Access Compliance Report Public Rights-of-Way (Curb Ramps)

Main Street: N/A Cross Street: VANDERLIP_AVE Location: SE

ADA ID: RPAT211006094256 Ramp Type:Type 1 - Perpendicular Initial Pass/Fail: Fail Overall Compliance: No Severity Score: 16

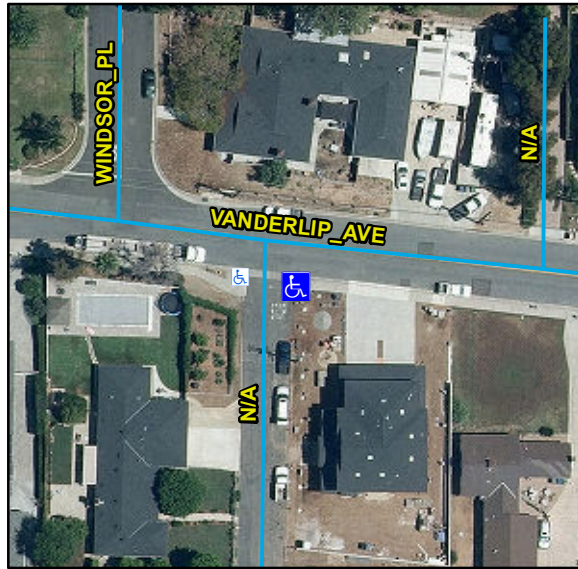
Compliance	Description	Data	Compliance	Description	Data
N/A	Ramp Length (in)	73	N/A	Flare Type LT	
Yes	Ramp Width (in)	75			N/A
No	Ramp Run Slope (%)	9.1	N/A	Flare Slope LT (%)	N/A
No	Ramp Cross Slope (%)	3.5	N/A	Flare Traversable LT	N/A
N/A	Landing Present	N/A	N/A	Flare Type RT	
N/A	Landing Length (in)	N/A			N/A
N/A	Landing Width (in)	N/A	N/A	Flare Slope RT (%)	N/A
N/A	Landing Run Slope (%)	N/A	N/A	Flare Traversable RT	N/A
N/A	Landing Cross Slope (%)	N/A	N/A	DWS Provided	N/A
N/A	Landing Movement Obstructed?	N/A	N/A	DWS Contrast	N/A
	Landing Movement Type	N/A	N/A	DWS Length (in)	N/A
N/A	Landing Shared	N/A	N/A	DWS Full Width	N/A
N/A	Clear Space	N/A	N/A	DWS Offset Left (in)	N/A
N/A	Clear Space To Crosswalk (in)	N/A	N/A	DWS Offset Right (in)	N/A
N/A	Marked Crosswalk 1	No	N/A	Marked Crosswalk 2	N/A
	Crossing 1 Direction	W		Crossing 2 Direction	N/A
	Marked Crosswalk 1 Width (in)	N/A		Marked Crosswalk 2 Width (in)	N/A

Remove & Replace Entire Ramp.
